CITY OF  
SPARTANBURG

NEW CITY  
OFFICES  
440 S. CHURCH

REVISION  
REVISION # 1 Date: 1/15/2016  
Revision 1 Dimensional Changes

DRAWING NO.  
COS 4.0

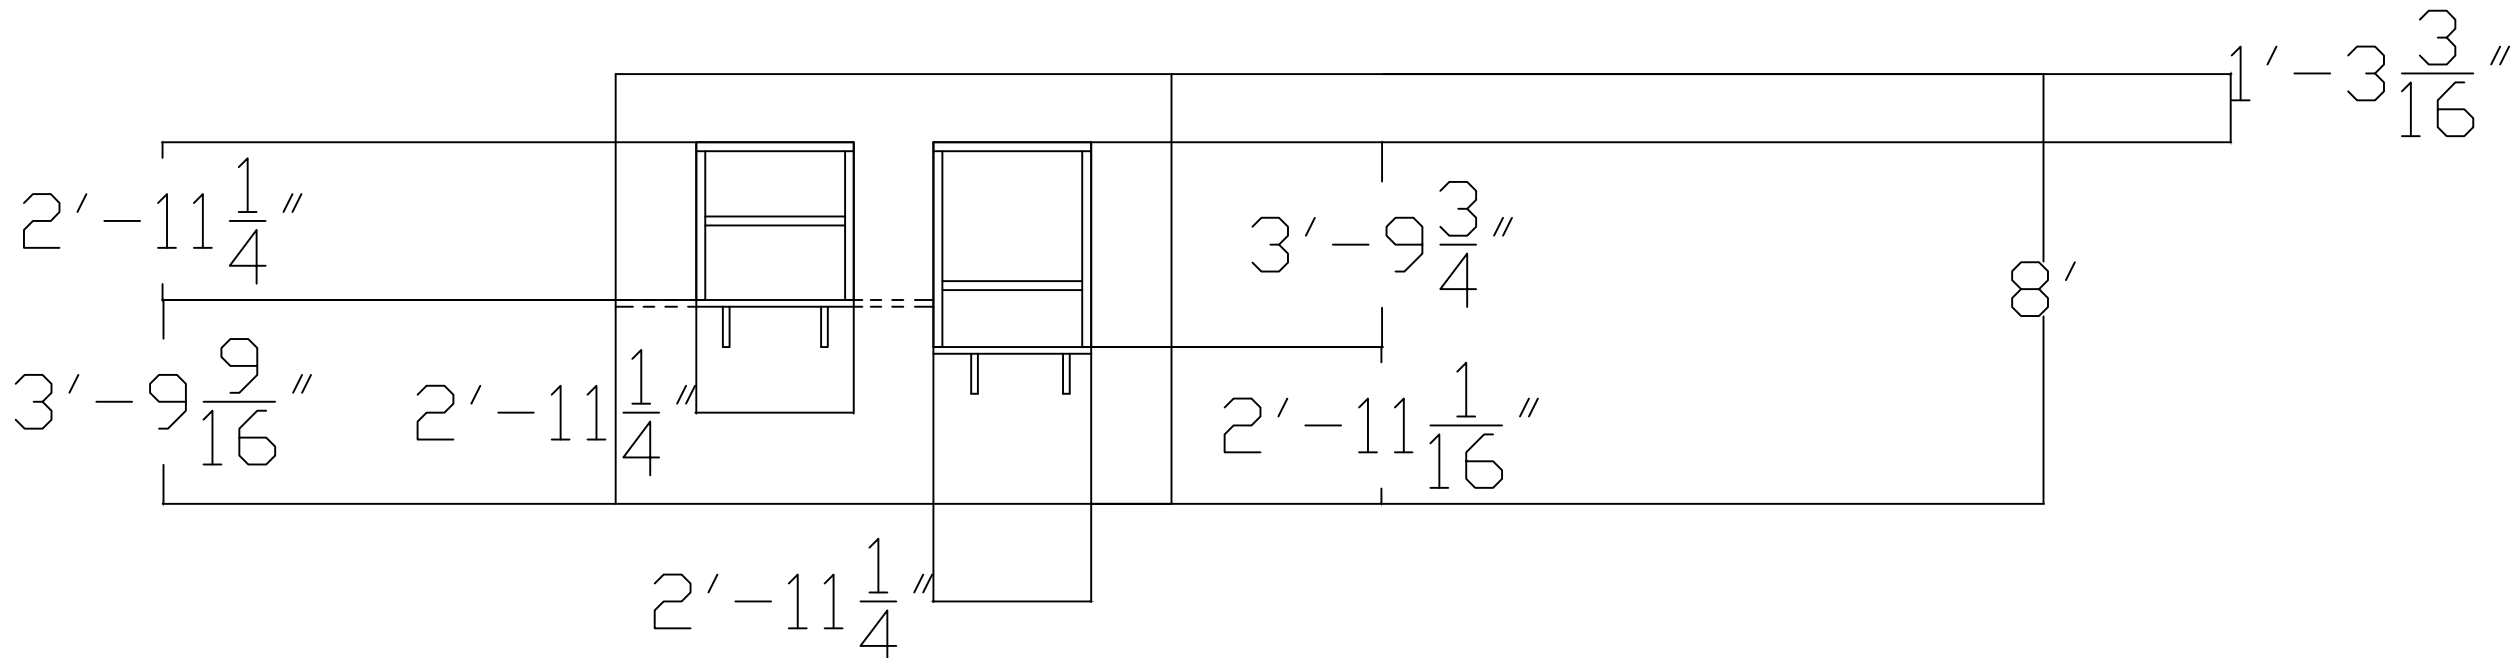
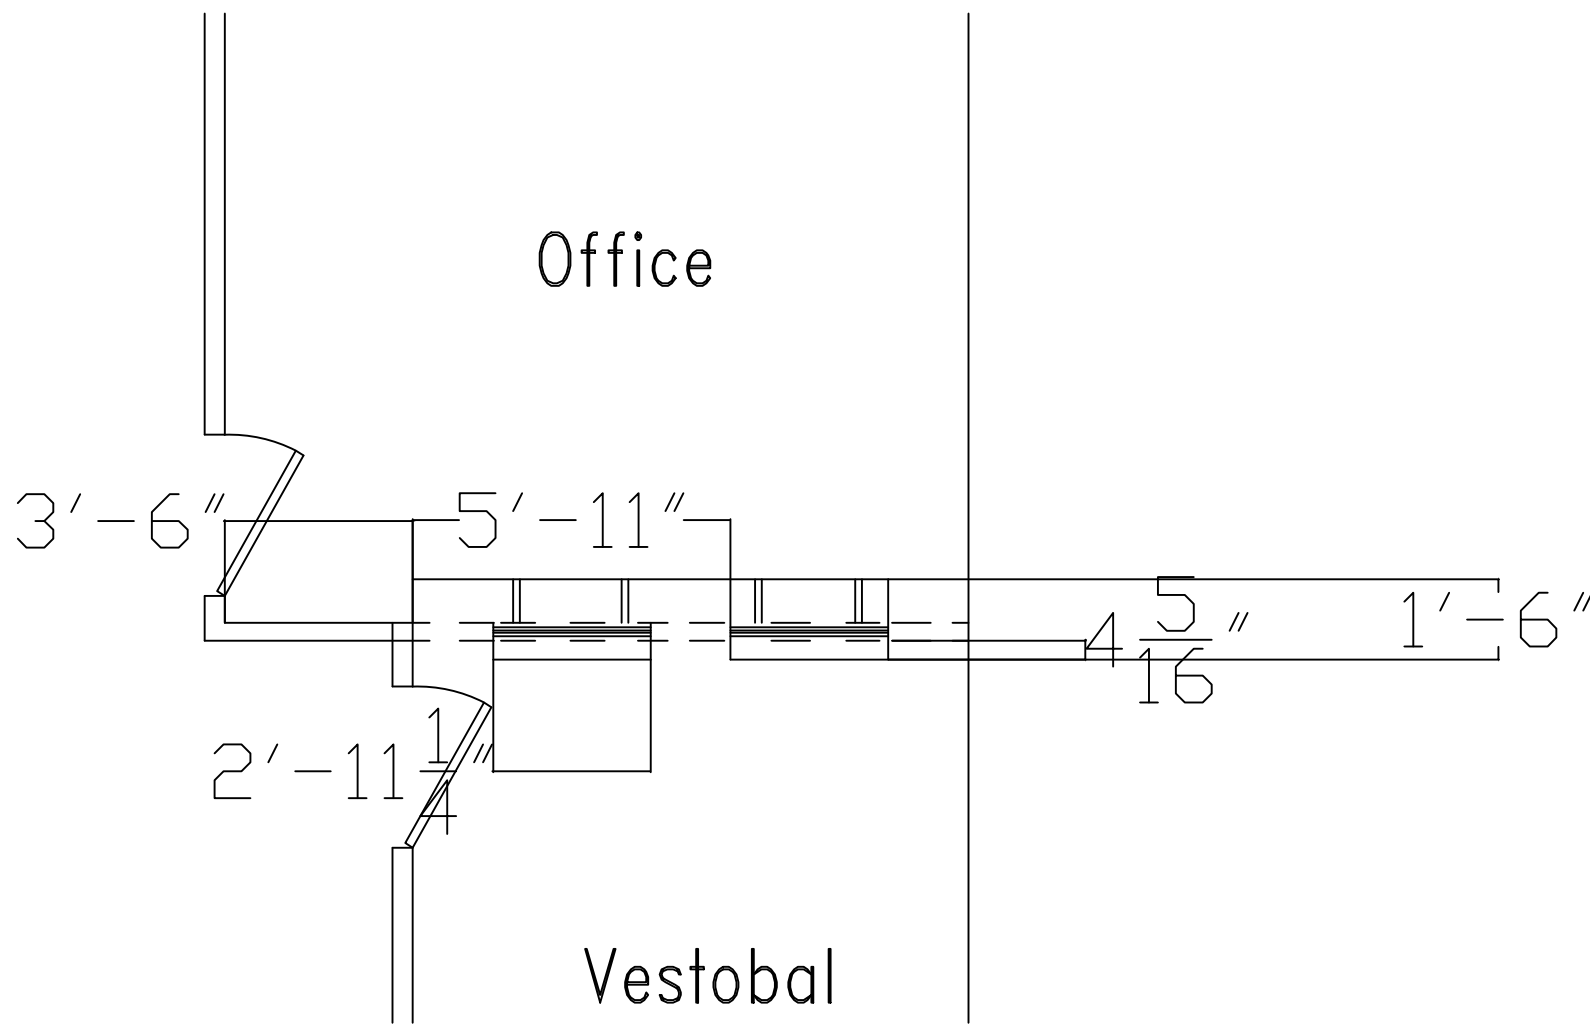
- Notes:
1. Changes to the counter of the front entrance have been change from the original drawing where dimensional error occurred.
  2. Changes to the counter of the front entrance have been change per discussions with Building Inspection Department.
  3. Changes are shown on the revised detail drawing dated 1/15/2016 to reflect aluminum framed window. These windows will be owner provided and will be installed by outside vendor. Contractor is responsible for the finish opening.
  4. Counter space shown will be 3'0" long on the entrance side of the wall and 5'11" on the office side.
  5. The shorter counter shown will be 3'0" long on the entrance side of the wall and 3'0" on the office side.
  6. Contractor will install a header above the top of the window framing per the drawing.
  7. Window frames will be on site prior to framing for reference during framing.
